SR-2 – ADVISORY STAFF REPORT (03-06-2026)

ADDRESS: 1656 W BOSTON BOULEVARD

APPLICATION NUMBER: HDC2026-00006

SCOPE: ENCLOSE REAR PORCH (WORK COMPLETED), PARTIALLY DEMOLISH REAR PORCH ENCLOSURE, INSTALL DECK

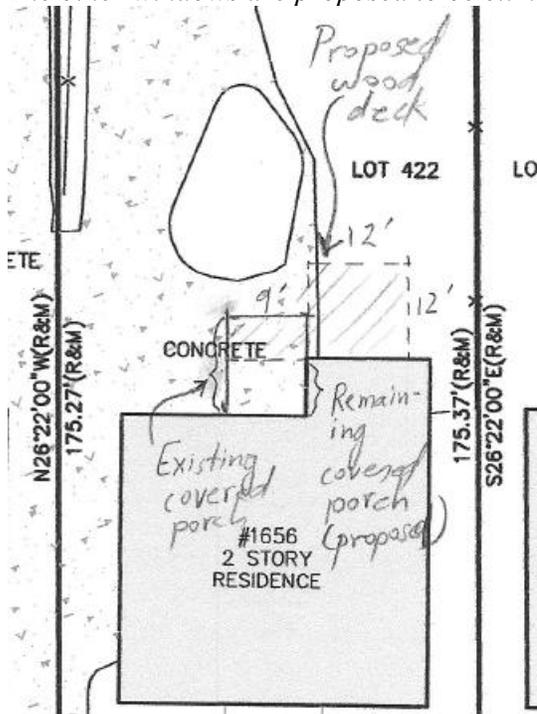
- Regarding color, the open porch had been painted white to match the trim on the historic house. That trim color, as long as it was a yellowish white, follows Color System C for this house. Once the porch was enclosed with siding, that siding was painted B11 Grayish Olive Green. That color is approved in Color System C for shutters, but not for body or trim.

- Regarding the windows and door on the rear enclosed porch, staff does not think the windows on the rear enclosure are compatible with the historic house because the windows on the house are vertically oriented, sash-style windows, whereas the enclosed porch has horizontally oriented sliders. The proportion of these newer windows is not compatible with the house. Staff does not find the aluminum storm door to the enclosed porch incompatible.

From applicant materials, with staff mark-up. The portion of the enclosed porch outlined in red is proposed to be demolished. Afterward, the remaining enclosure will generally align with the concrete foundation wall seen here and the rear wall of the brick wing. The brick wing and sided porch enclosure are proposed to be flush with each other once the work is complete. The resulting rear addition would only have one window, next to the exterior door. The other windows are proposed to be eliminated.

1. The color to be used on the siding on the rear enclosed porch addition must be reviewed and approved by staff.
2. Because slider windows are incompatible with the house and district, a window that is more vertically oriented and is a sash-style window must be substituted for the window on the rear enclosed porch and must be reviewed and approved by staff.
3. The skirt material must be reviewed and approved by staff.
4. The design of the skirting below the deck must be revised to be compatible with the house and must be reviewed and approved by staff.
5. The paint or stain for the deck and skirting must be reviewed and approved by staff.

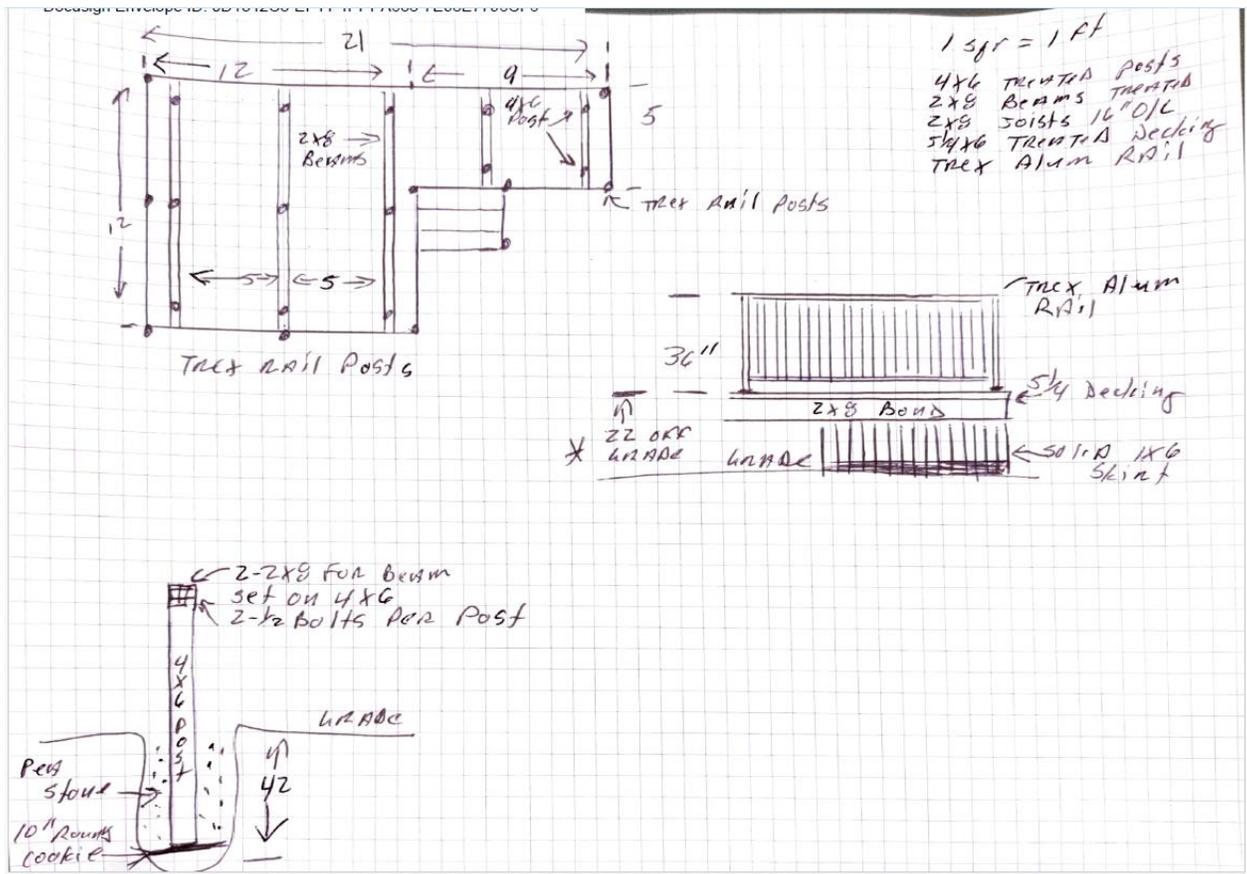
From applicant's materials. The smaller, rectangular portion of the deck is proposed to be the same size as the demolished part of the enclosed porch. The altered enclosed porch and the smaller portion of the deck would have the same footprint as the former enclosed porch. Additionally, a larger section of the deck would be built that would span across most of the brick rear wing as well, so the entire deck would span from the center of the rear wall almost to the eastern wall of the house.

- Staff finds the proposed deck compatible with the house in size, scale, and massing. Staff believes that the proposed black aluminum guardrail will be compatible with the historic house and the deck, and that the wood components of the deck structure should be stained or painted. The proposed skirting material was not provided and needs to be confirmed. It should be painted or stained wood. Staff believes that the proposed treatment composed of vertical boards forming a solid skirt under the deck is a contemporary treatment and would not be compatible with the historic house.
